NORWOOD ORCHARDS RESIDENTS ASSOCIATION

22 December 2016

Comment on the Paterson Park Development Application Amendments

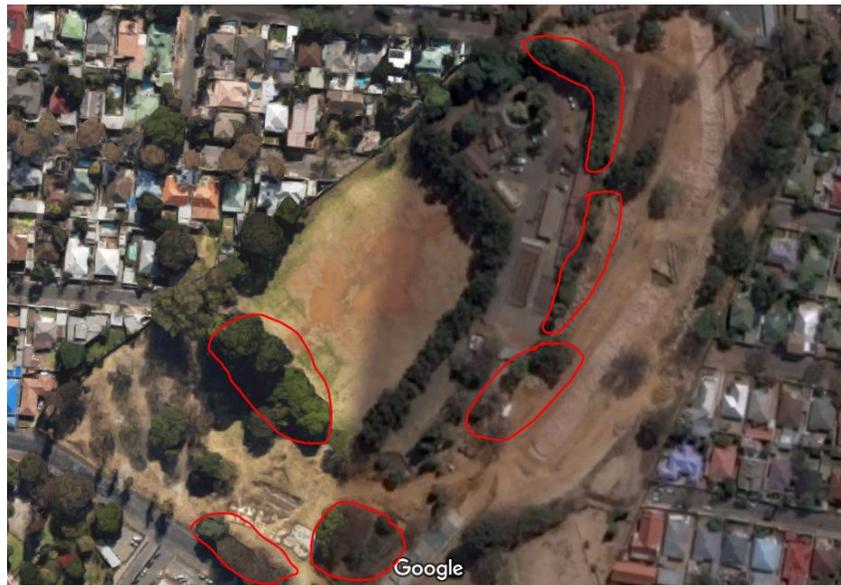
- The retention of mature landscaping on development parcels adjoining Norwood. Mature landscaping acts as a noise buffer, creates a privacy screen, and creates a more pleasant environment. We would like the City to explore mechanisms to protect the following mature landscaping bordering Norwood (marked in **Red**):

- Our previous engagements with ASM indicated a “buffer zone” in the form of a building setback on the Norwood border. This would include the retention of the mature landscaping indicated. This not appear to have been carried through on the new design proposals. We urge the City to find a planning mechanism to enforce this retention.
- Retention of important mature landscaping elsewhere on or bordering the development parcels. Again, this would create a more pleasant public environment and improve quality of life of the new residents. We would like the City to explore mechanisms to protect the following mature landscaping bordering Norwood (marked in Red):
